Project B1904193 (Activity 1.5)

Re: Field Reconnaissance Report MP 38.1 and MP47.2 HDD Sites
Demicks Lake Pipeline Right-of-Way
McKenzie County, North Dakota

C. Construction Plan Review and Recommendations

Photograph 6: MP38.1

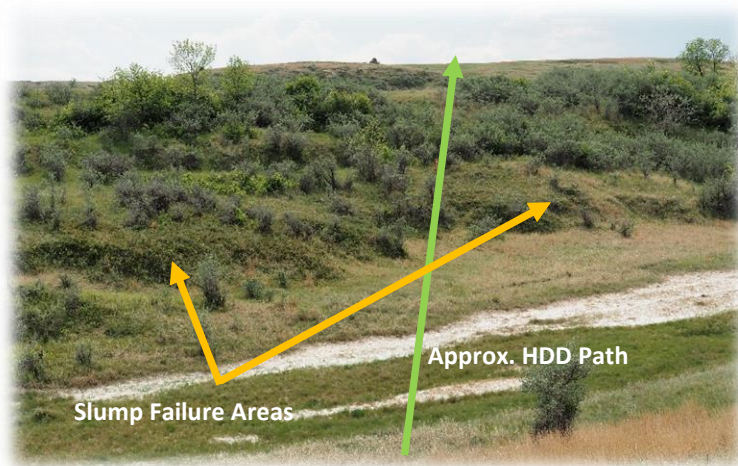
View facing southwest slightly oblique to alignment illustrating existing slumping.

The slump failures appeared to be shallow in nature. Based on information provided by JTAM ENGINEERING, the HDD will be no less than 20 feet below the lowest point across this area. Due to the

planned HDD installation technique and depth, it is our opinion there is little risk of short- or long-term slope instability impacting the pipeline as it is proposed to be installed.

Photograph 7: MP47.2

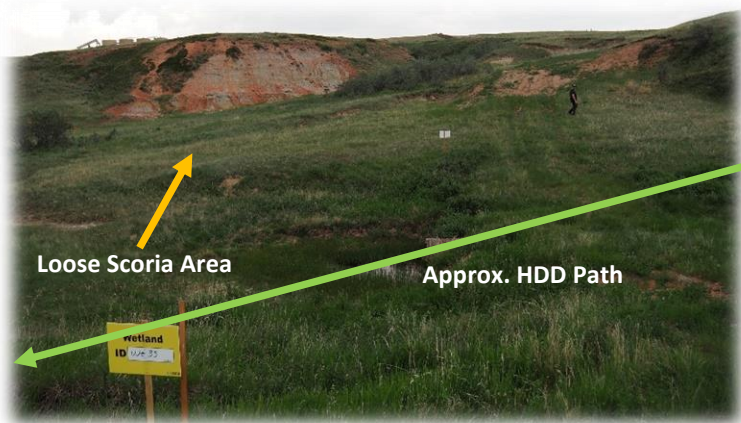
Due to an existing wetland area (yellow sign in Photograph 7 below), HDD installation is planned for this site as well. The elevated portion of the ground in the area is comprised of scoria, which was observed to be cascading down the slopes. The slopes in the area appeared to show no signs of failure, and since the site is planned for HDD installation of the pipeline, it is our opinion that there is little risk of instability at this site.

View facing northeast oblique to alignment towards the outcropping bank.

HORIZONTAL DIRECTIONAL DRILL CHERRY CREEK, TWO PEM WETLANDS & EPHEMERAL STREAM M.P. 37.88 DEMICKS LAKE PIPELINE INDEX #10597			
DES.: EP	AFE#:	DATE: 04/19/19	
DR.: EP	DWG. NO.:		
CH.: CR	SCALE: NOTED		
AP.: CR	CAD#:	OPL008JTAM-MP-20-006	REV. 1

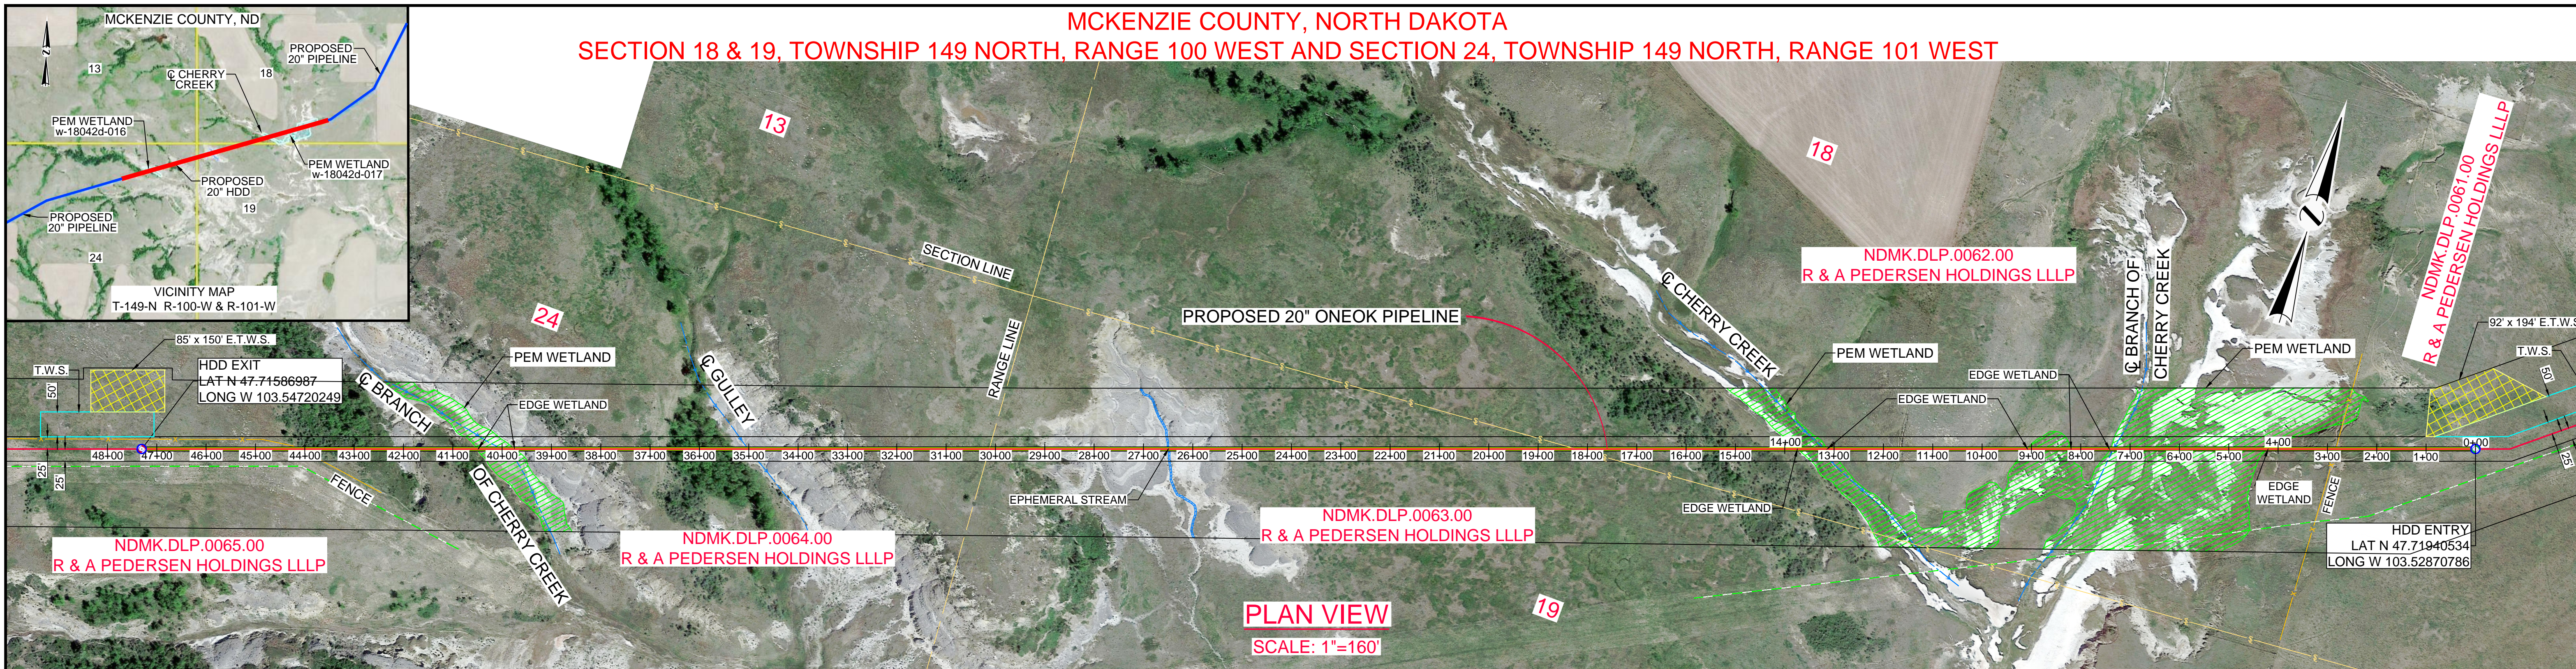
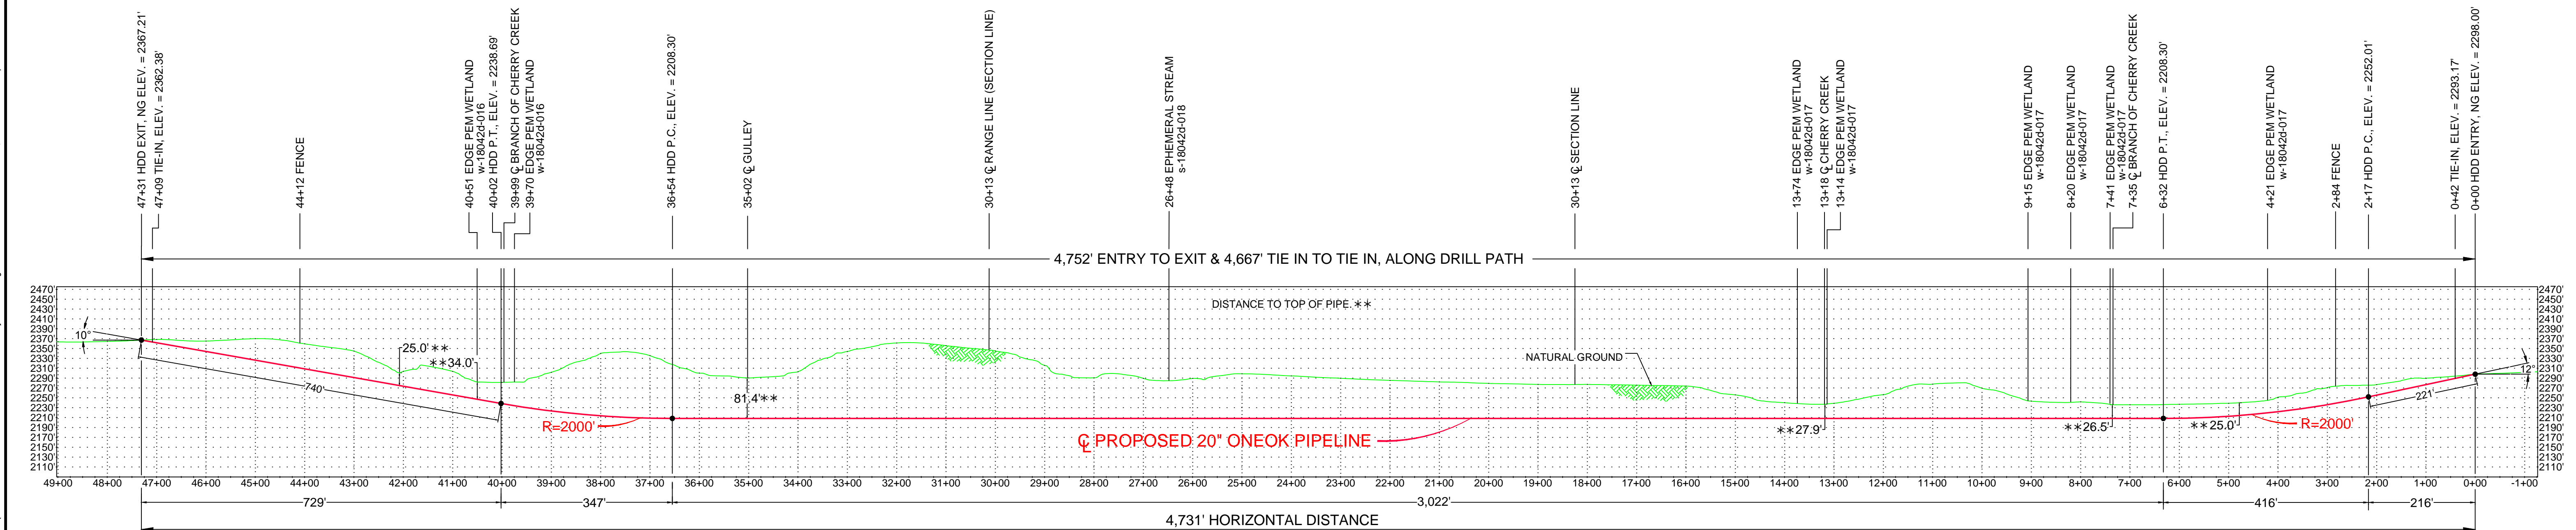
This section of pipeline near MP38.1 extends horizontally from east to west for approximately 4,731 feet. Based on the construction plans, the minimum depth below low points (wetlands, valleys, etc.) is 25 feet. The pipeline in this area crosses two wetlands, Cherry Creek, and several eroded valleys. The geologically unstable area was identified between Stations 33+00 and 38+00. Based on our site reconnaissance in this area, there were several north/northeast facing slopes, particularly near Stations 16+00 (directly west of Cherry Creek) and 36+00 (within the 'unstable' area), which indicated slope instabilities. However, the slopes containing dense tree cover and indicate slump failures appeared to be shallow in nature and likely caused by historic erosion at the toe.

The planned depths below these areas' low points are about 28 feet (Station 16+00) and 81 feet (Station 36+00) below the existing ground surface. Based on the geologic conditions of these areas and the planned HDD depths, construction may proceed as planned. Geotechnically, the planned depth below wetland areas is sufficient.

HORIZONTAL DIRECTIONAL DRILL TWO PEM WETLANDS W-18042D-005 AND W-18042D-004 M.P. 47.21 DEMICKS LAKE PIPELINE INDEX #10597

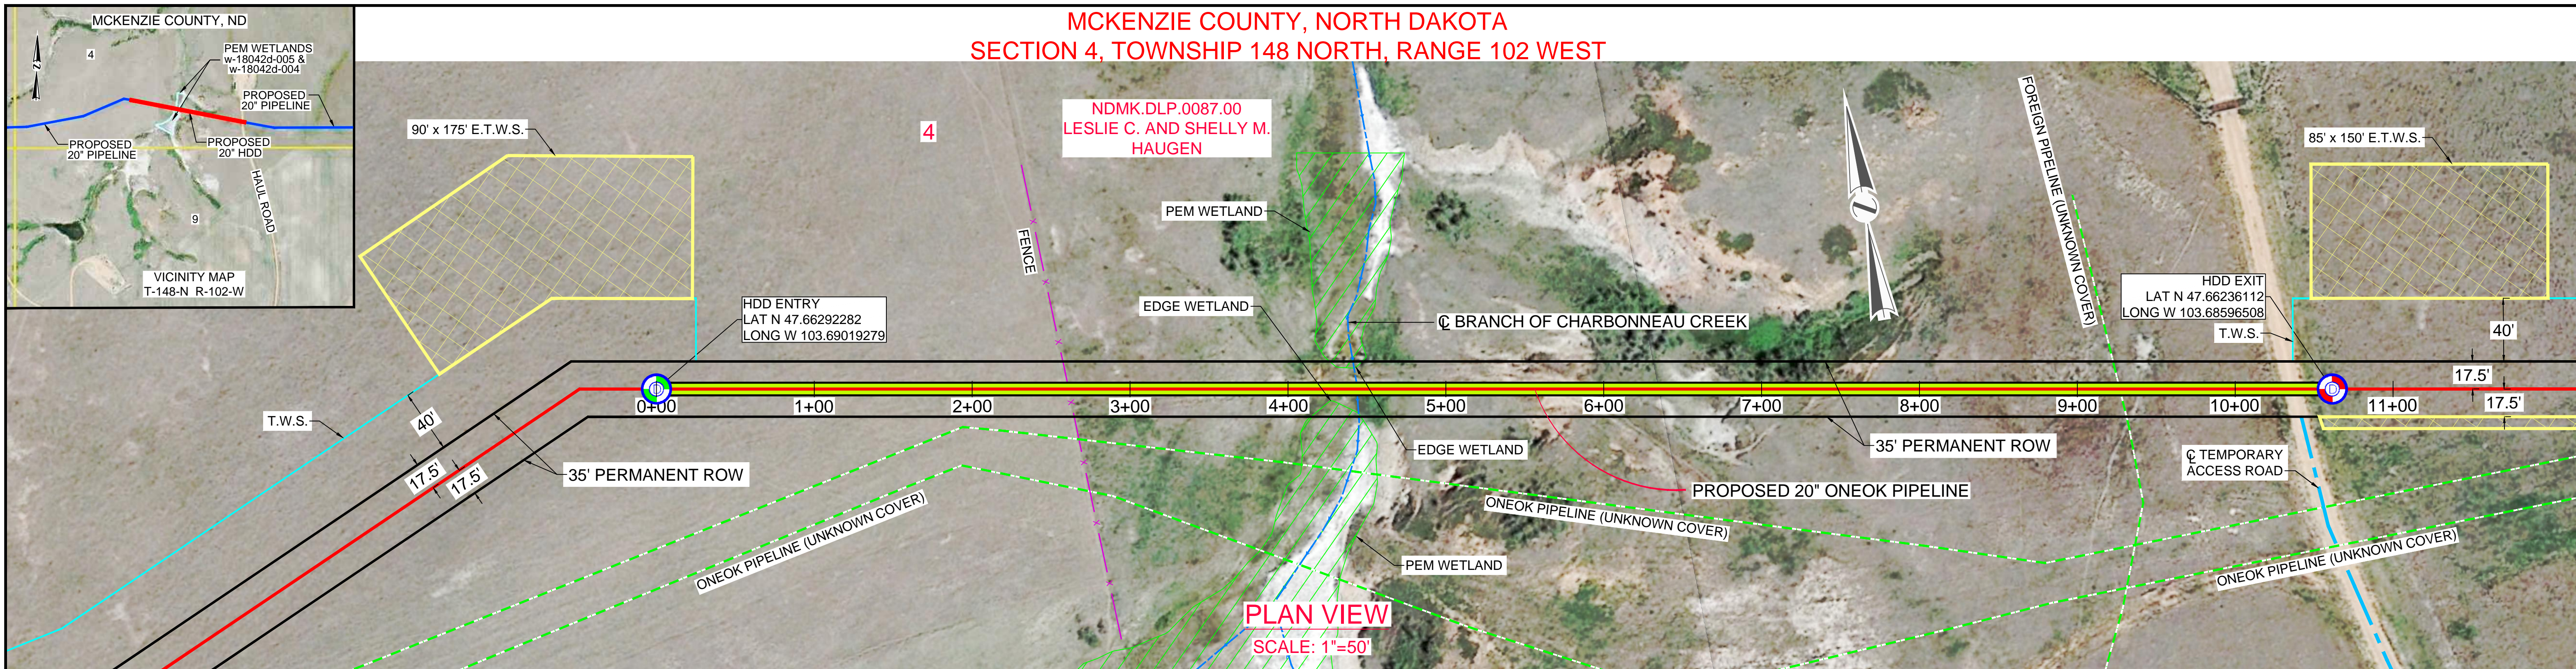
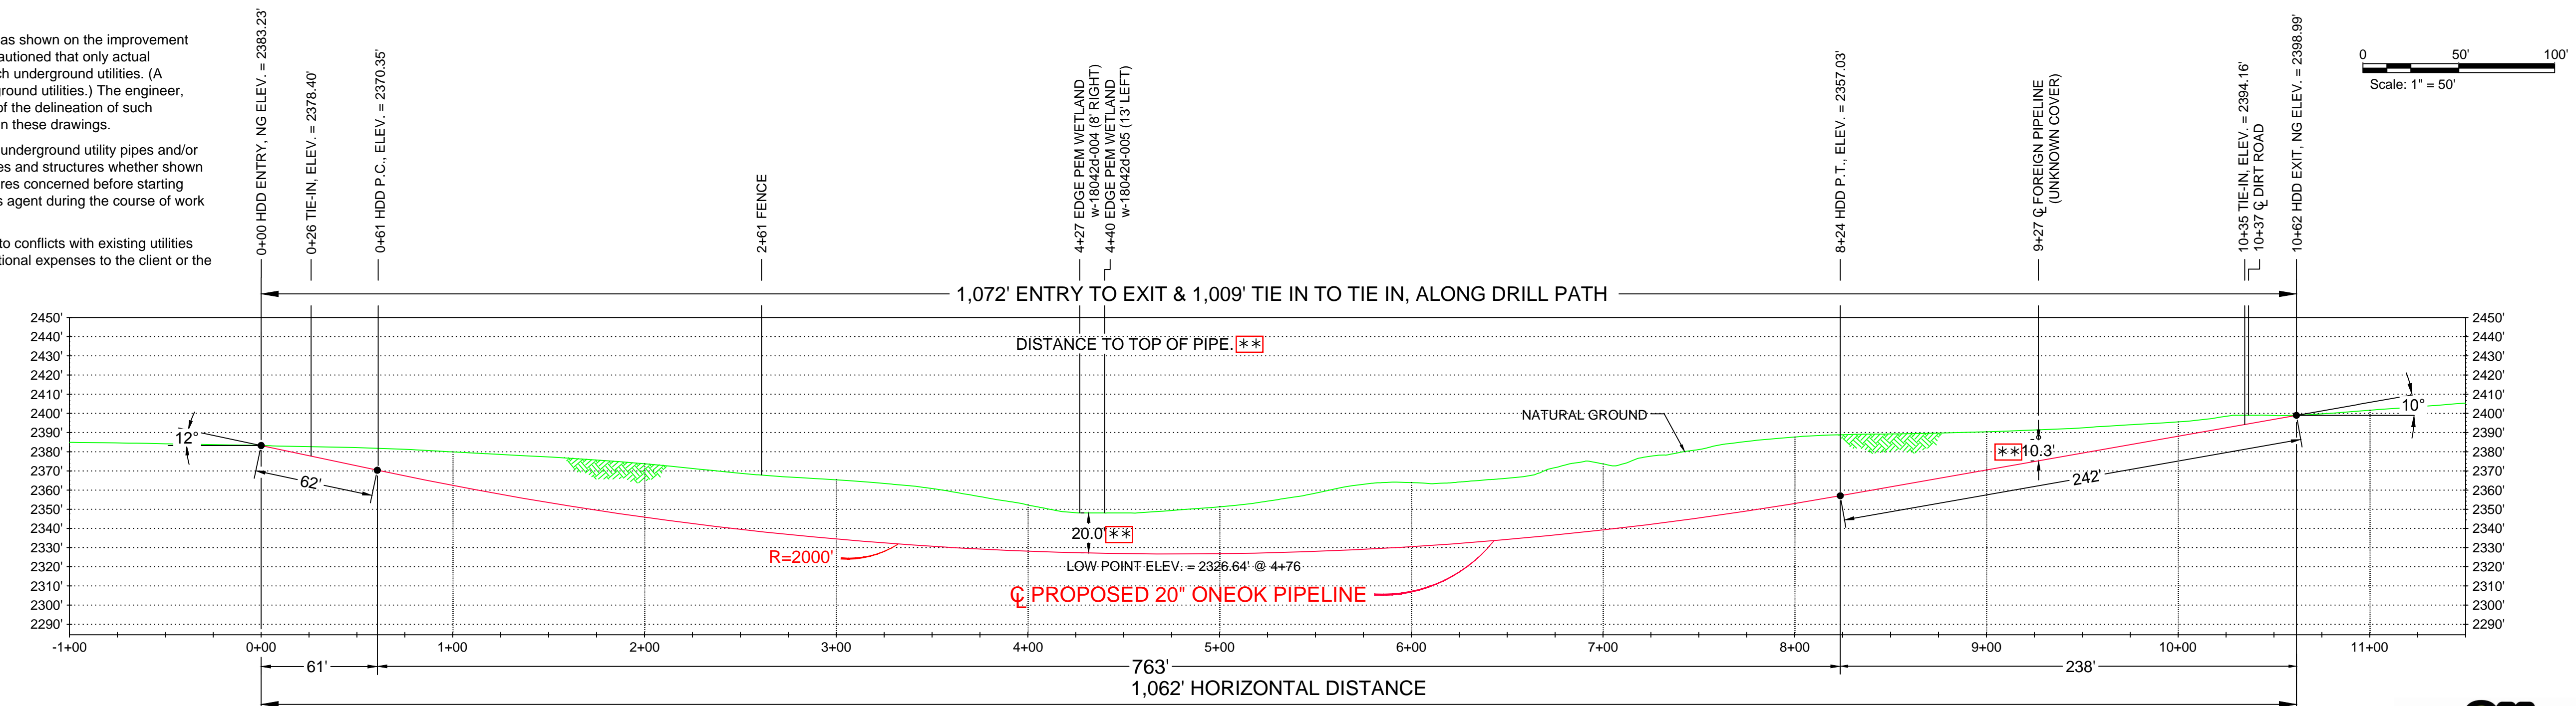
The pipeline near MP47.2 is planned to extend horizontally from east to west for approximately 1,062 feet. Based on the provided plans, the minimum depth below the wetland and potentially geologically unstable area (lowest point) is approximately 20 feet. The area of concern was identified between Stations 4+00 and 5+00. Based on our site reconnaissance in this area, there were no signs of slope instability or distress other than varying degrees of erosion/degradation within the surface scoria stratum.

The planned depth below the lowest point in this area is about 20 feet (Station 4+78) below the existing ground surface. Since there were no signs of slope instabilities and the HDD depth is sufficient, construction may proceed as planned.
